Shire of Dardanup

# ORDINARY MEETING

Wednesday, 1 November 2017  
Commencing at 5.00pm

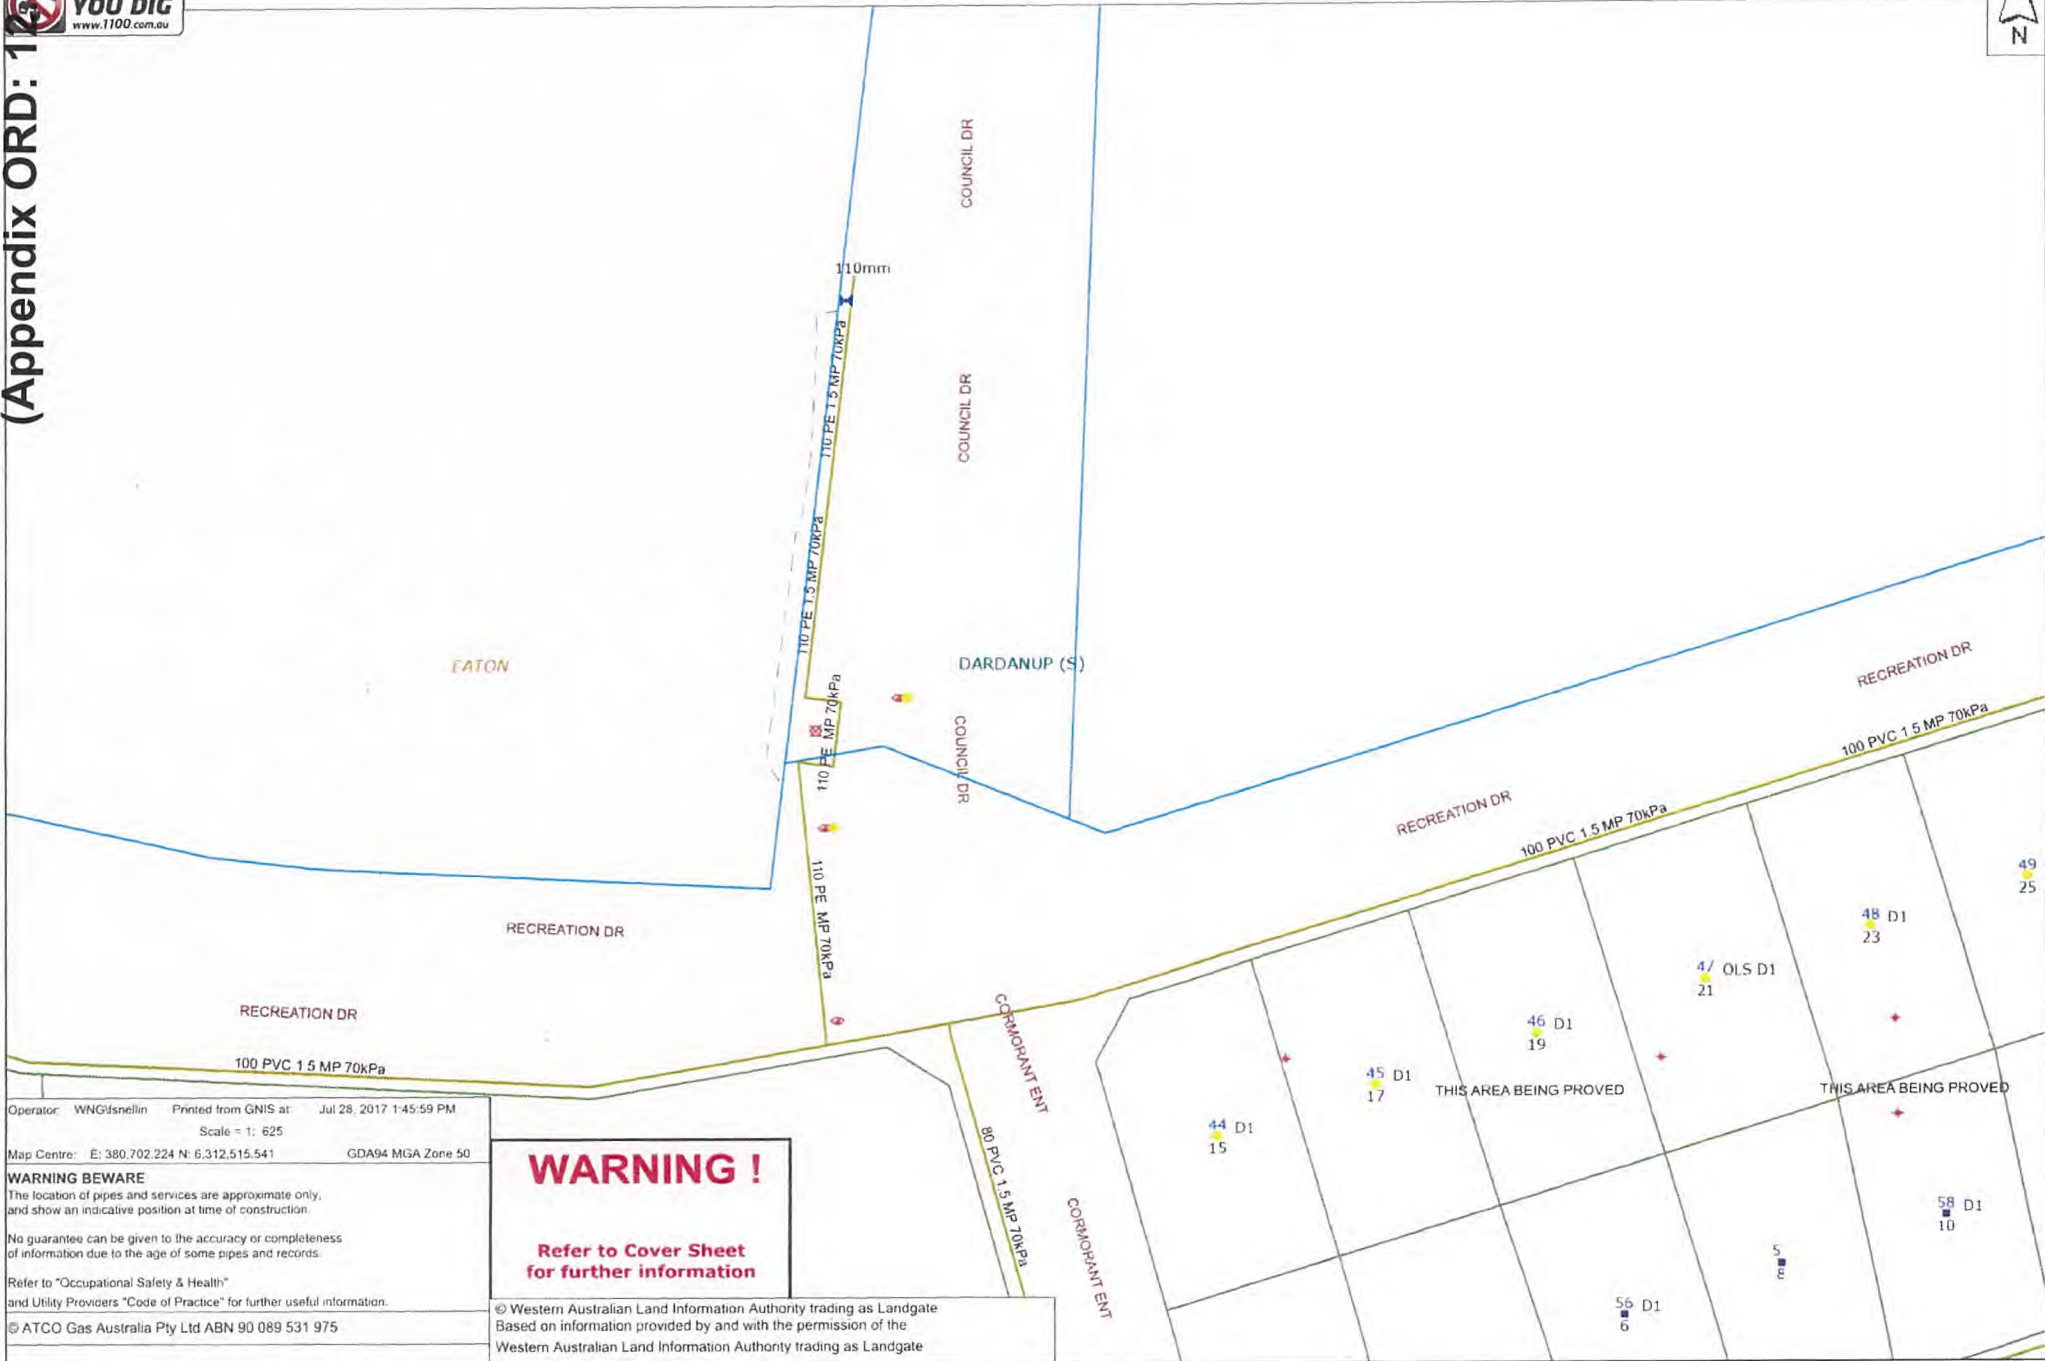
ATCO Gas is happy to work with the proponents to progress the relocation of the gas mains based on their future landuse of this area, so either the presence of our gas assets can coexist with the proposed development in an easement or are relocated to better suit the change in landuse. Any costs associated with the Realignments, or Easement document preparation and registration to the benefit of ATCO Gas, against the new Certificate of Title will need to be met by the proponent.

Please see the attached Figure for your record.

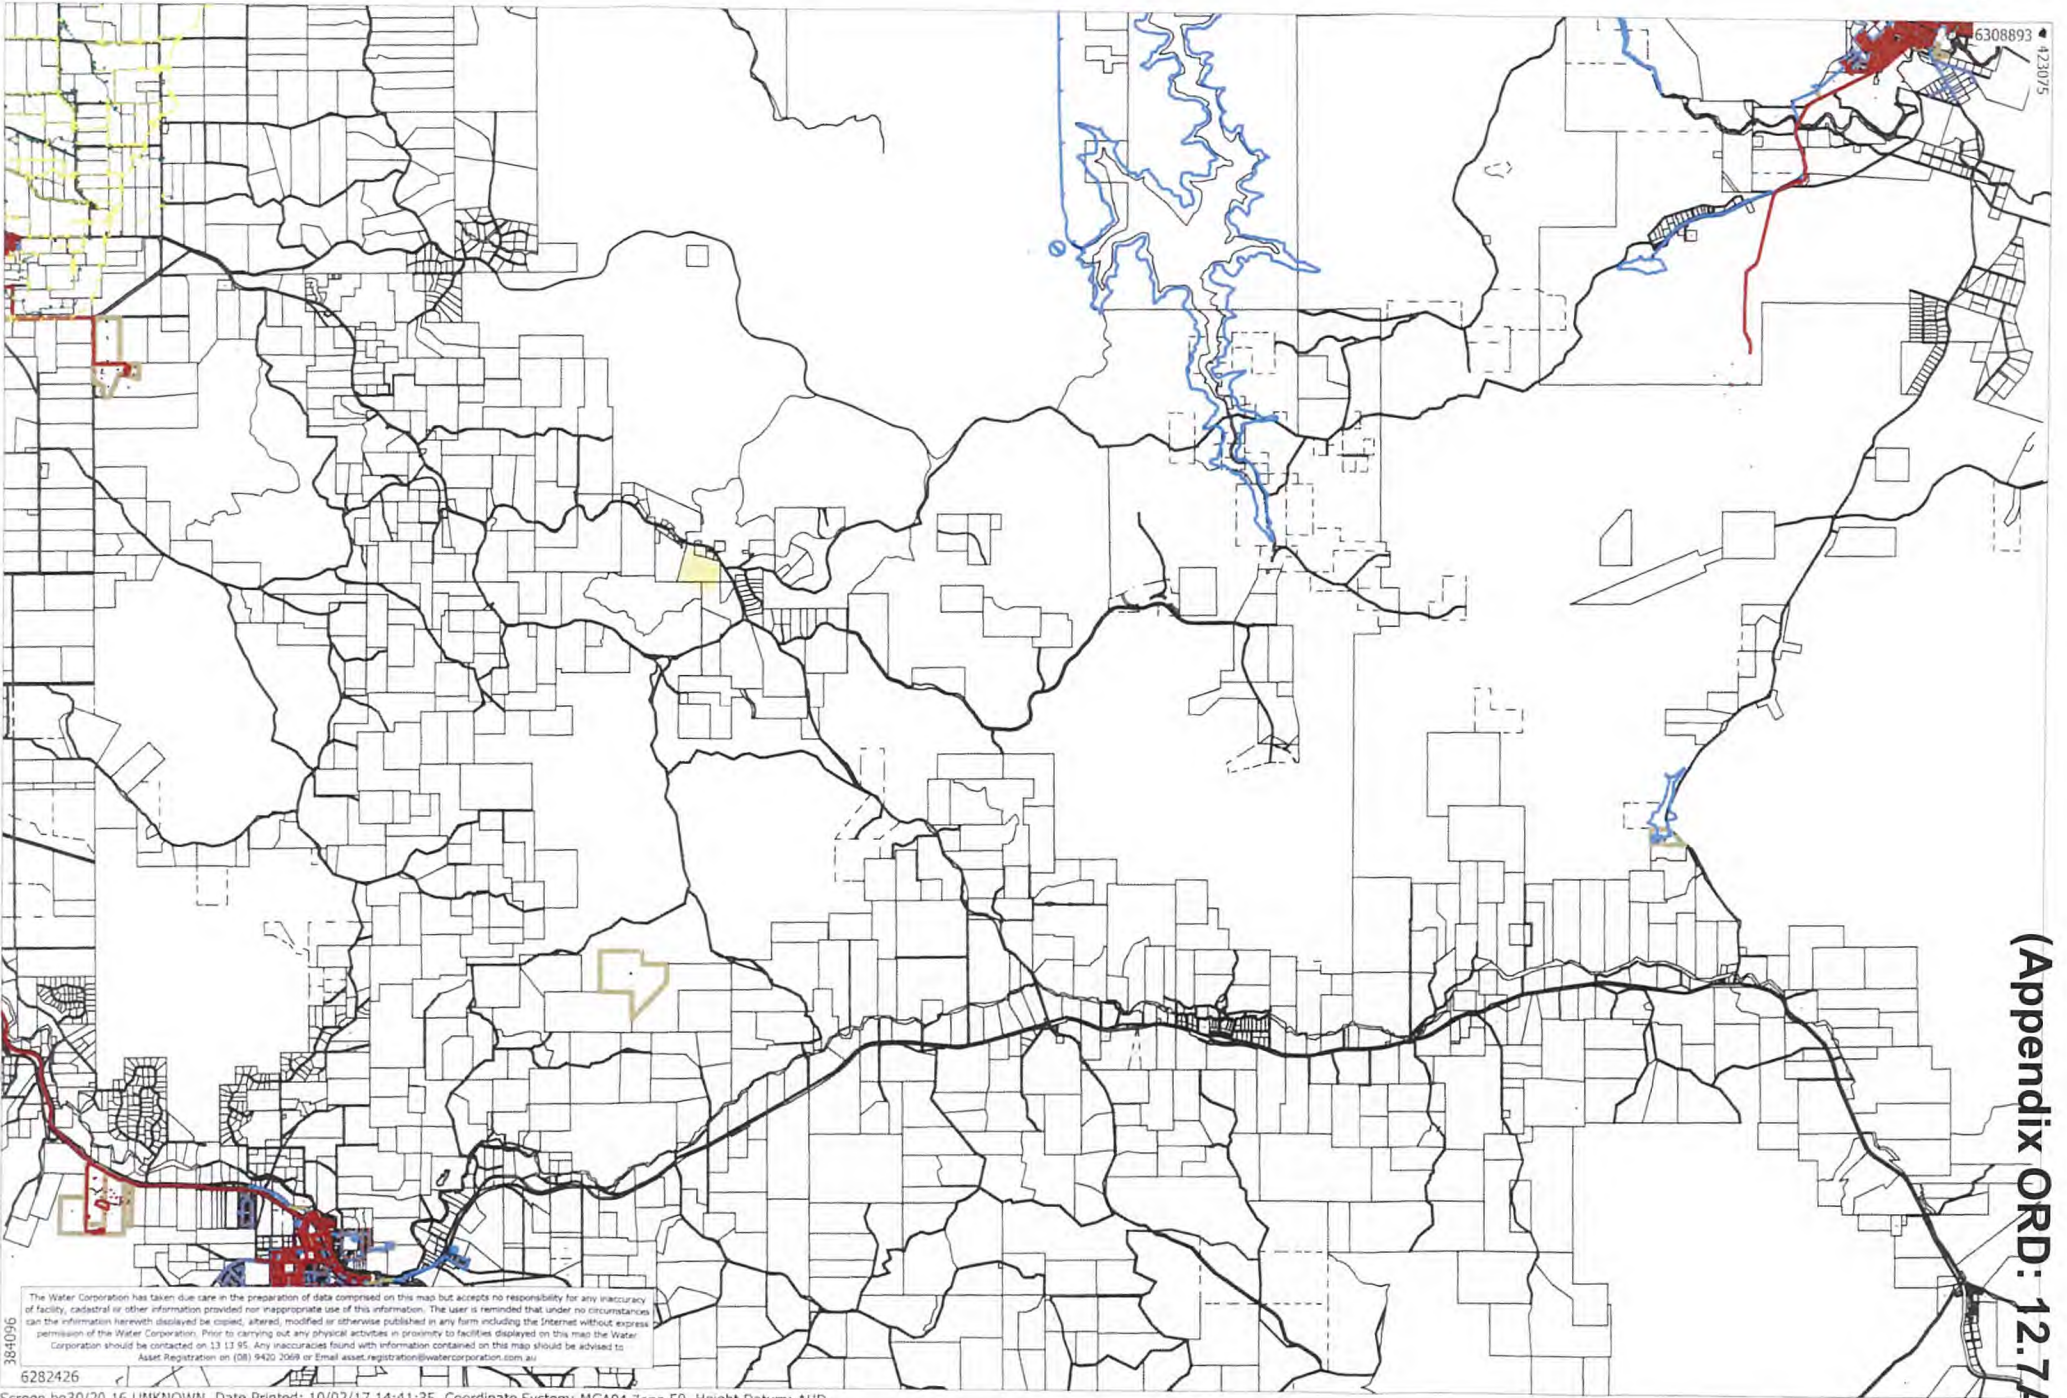
Reticulated Water & Wastewater services are remote from the subject Land.

The proposed changes to the Scheme do not appear to affect Water Corporation assets or operations.

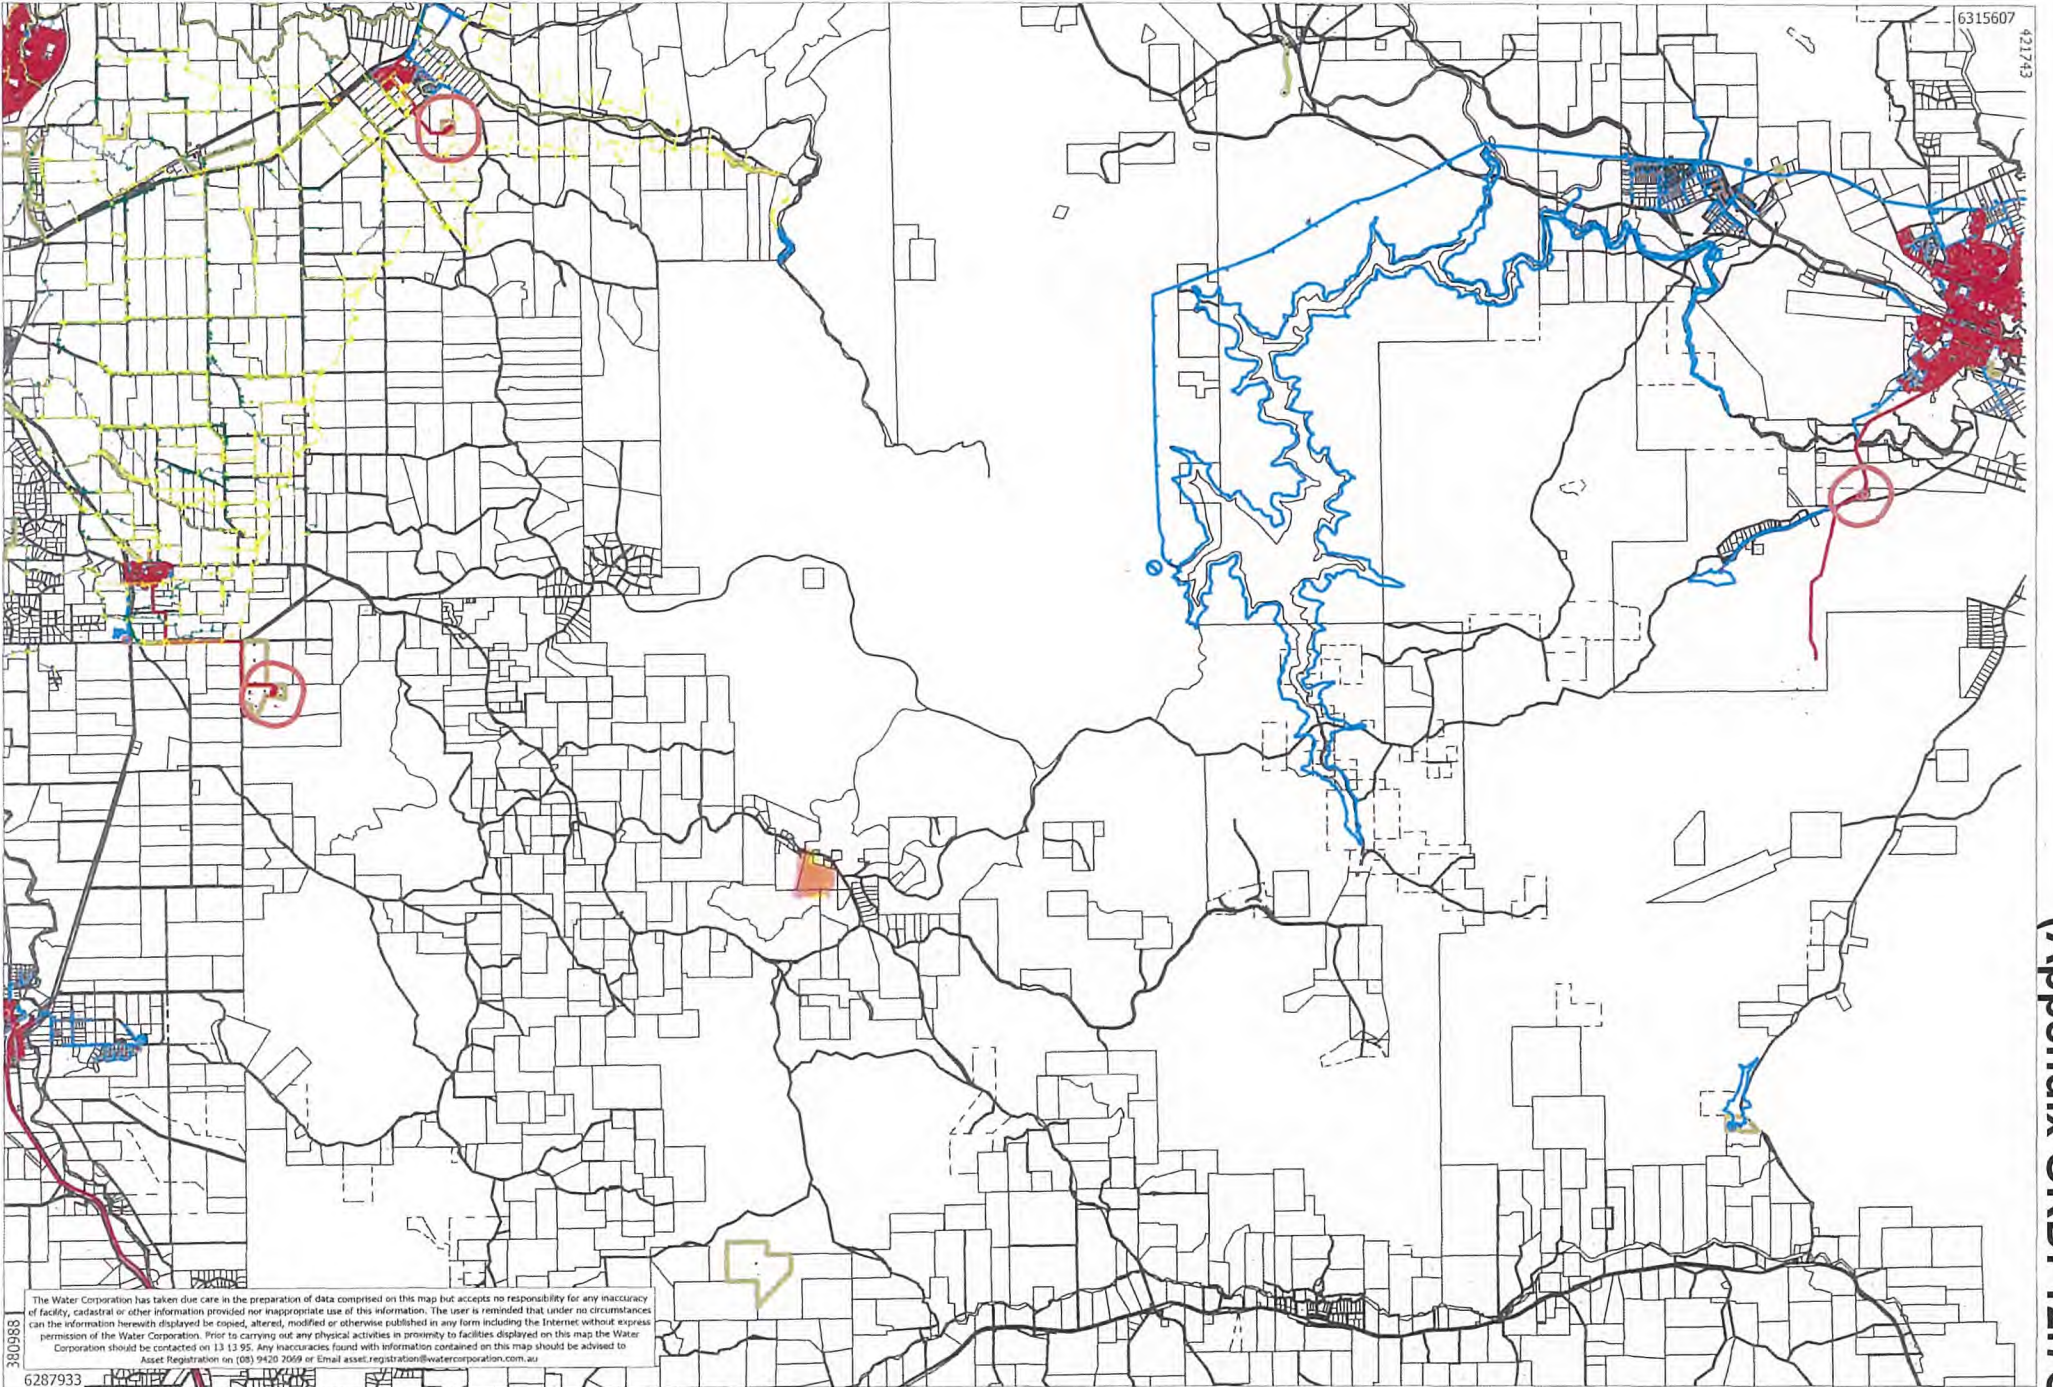
Reticulated water and sewerage services are remote from the subject land. (See attached plan) Therefore alternate servicing arrangements will be required.
